PLANNING COMMISSION REGULAR MEETING VIRTUAL PLANNING COMMISSION REGULAR MEETING

**TUESDAY, DECEMBER 22, 2020
7:00 P.M.**

A. CONTINUED - PUBLIC HEARING TO REVIEW AND CONSIDER THE SIX-LOT RESIDENTIAL PLANNED DEVELOPMENT PROJECT INITIAL STUDY/MITIGATED NEGATIVE DECLARATION ENV-02-16; GENERAL PLAN MAP AMENDMENT GPA-02-18; SPECIFIC PLAN MAP AMENDMENT SPA-01-18; ZONING MAP AMENDMENT ZOA-01-18; VESTING TENTATIVE RESIDENTIAL SUBDIVISION MAP MAP-01-16; DEVELOPMENT PLAN PERMIT DP-01-19; AND TREE REMOVAL PERMIT TRP-31-19. RECOMMENDATION:

SUBJECT: Public Hearing to review and consider the six-lot Residential Planned Development Project Initial Study/Mitigated Negative Declaration ENV-02-16; General Plan Map Amendment GPA-02-18; Specific Plan Map Amendment SPA-01-18; Zoning Map Amendment ZOA-01-18; Vesting Tentative Residential Subdivision Map MAP-01-16; Development Plan Permit DP-01-19; and Tree Removal Permit TRP-31-19.

Figure 1. Google Streetview image of the proposed Project Site and the hill that would be graded to accommodate development.

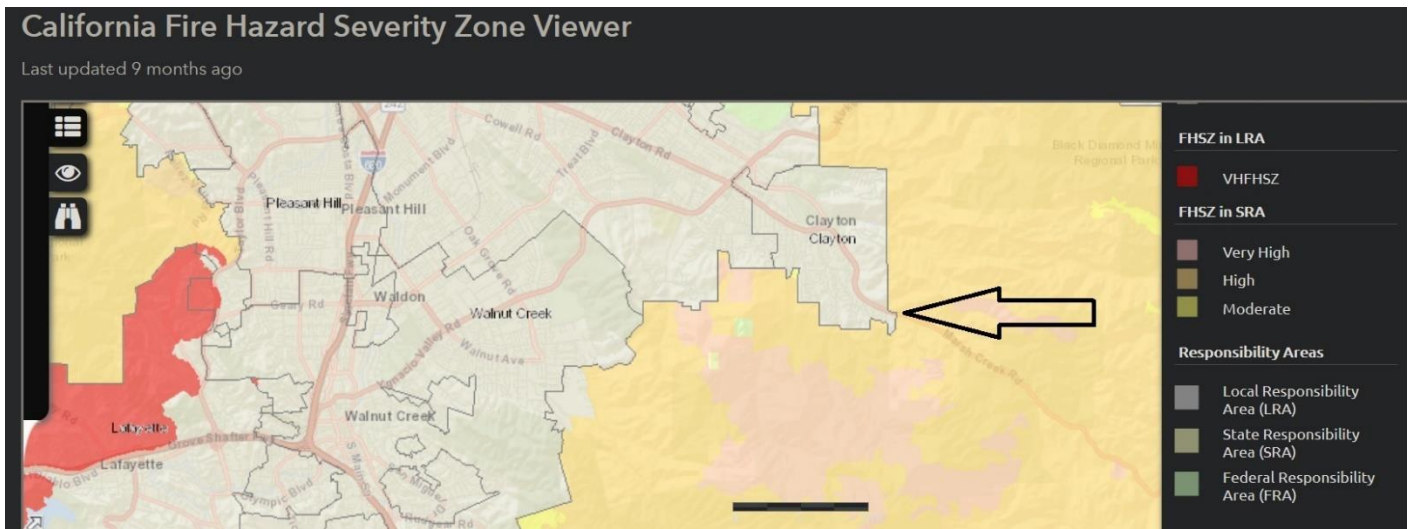
Attachment O of the proposed Initial Study and Mitigated Negative Declaration for the Project shows significant grading of the topography of the Project site directly north of units 1 through 5. Figure 1 (below) is a Google Streetview image of the Project site showing the hill that would be graded to accommodate the six units proposed for the Project. Development that accommodates natural terrain to blend with the landscape is more aesthetically sensitive and oftentimes avoids biological impacts on plants and wildlife to a greater degree than development that relies on heavy grading. We encourage the Planning Commission to consider recommending reducing the number of units that would be constructed in the Project to help keep Clayton's hillsides intact.
